April 11, 2005

**MICHAEL DEVONSHIRE
HISTORIC PRESERVATION CONSULTANT**

Re: 755-757 Greenwich St., Manhattan

Photo 1: The dissimilar color and texture of infill brick is very visually obtrusive. Coursing of the new brick masonry does not replicate the original. Mortar joints in original bricks appear to have been widened to accommodate inappropriately wide new brick joints. Note grinder marks.

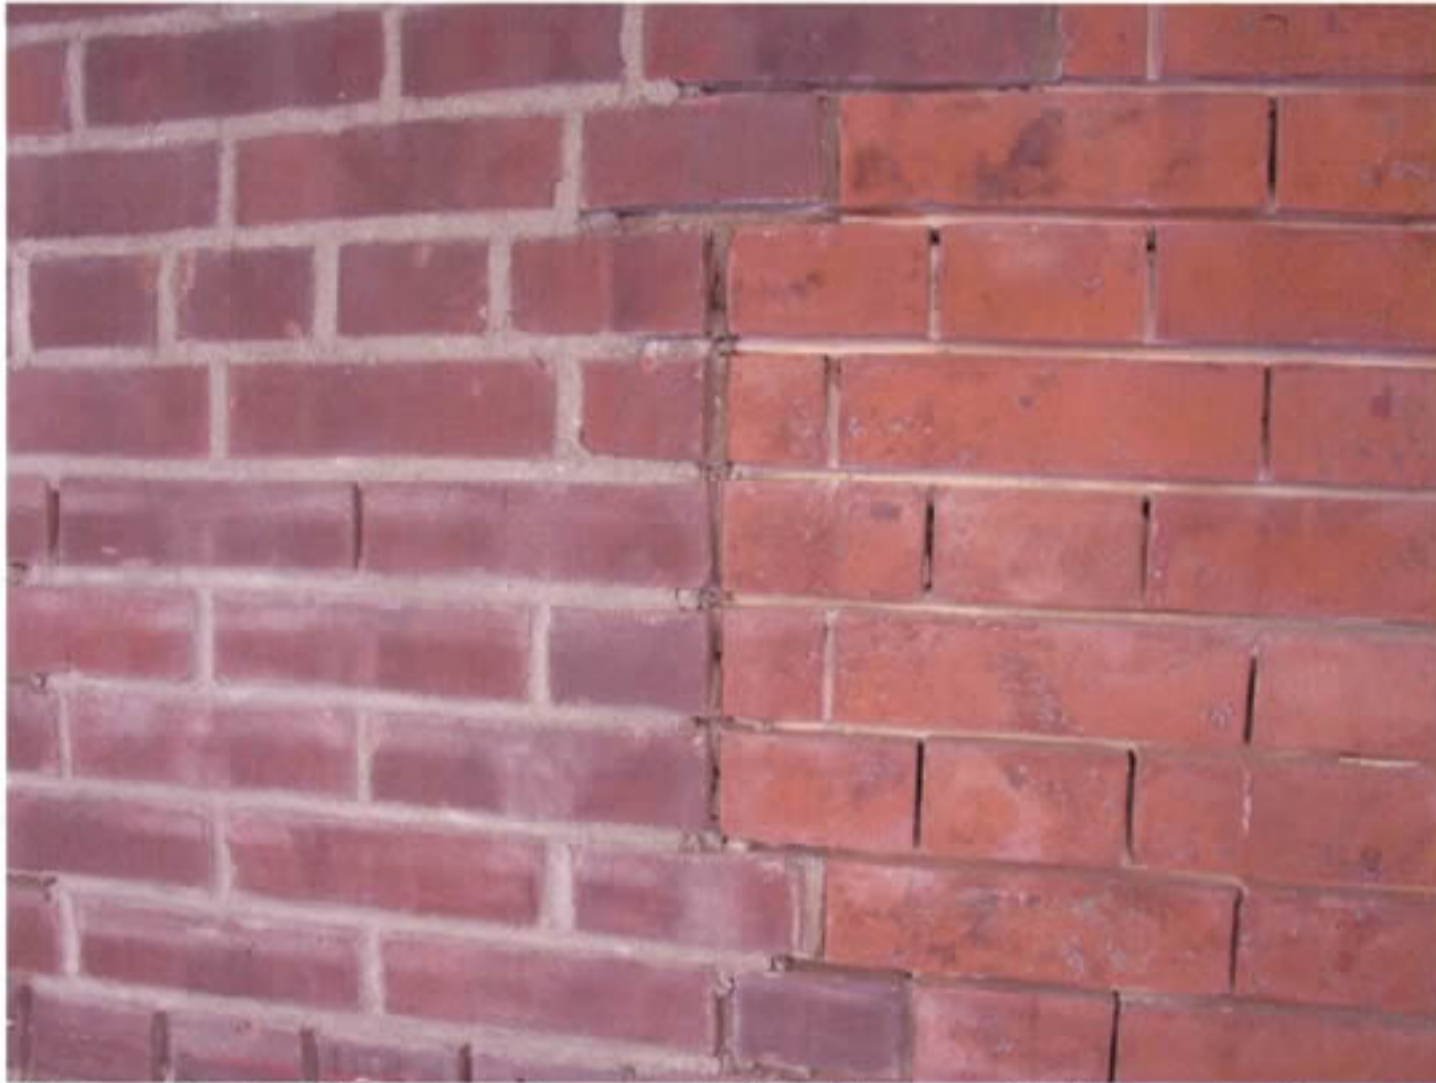
The existing original façade brick masonry has been infilled at several locations using brick which appears to be not pressed but hand struck, and of obtrusively dissimilar color (Photo 1). This has occurred not only at a large infill area on the Greenwich St. facade but also at newly cut window surrounds on the 11th St. façade. The newer brick has been laid in common bond rather than a replication of the original Flemish bond. Mortar joints on the original brick masonry system appear to have been a moderately uniform 1/8”, however, these have been cut out using a mechanical grinder. The horizontal joint cutting has been very poorly executed, and in some cases the joints are now 3/8” wide with “mistake” cuts to 1/2” at some locations, significantly and inalterably damaging original material.
